**DESIGN/PROCESS CHANGE NOTIFICATION**

Description of Change (From) :  
For TO3PF-3L package assembly in FSSZ  
Retract mold type: hole with EMC filled.

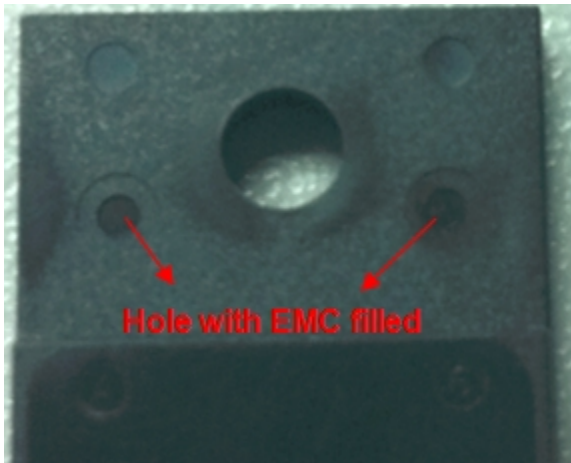
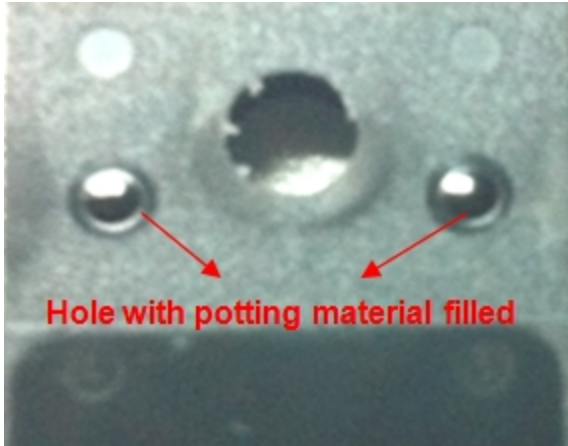
Description of Change (To) :  
Add alternative type of potting: hole with potting material(epoxy) filled.

Product quality was enhanced a lot of isolation performance. The change also help to improve mold process productivity.
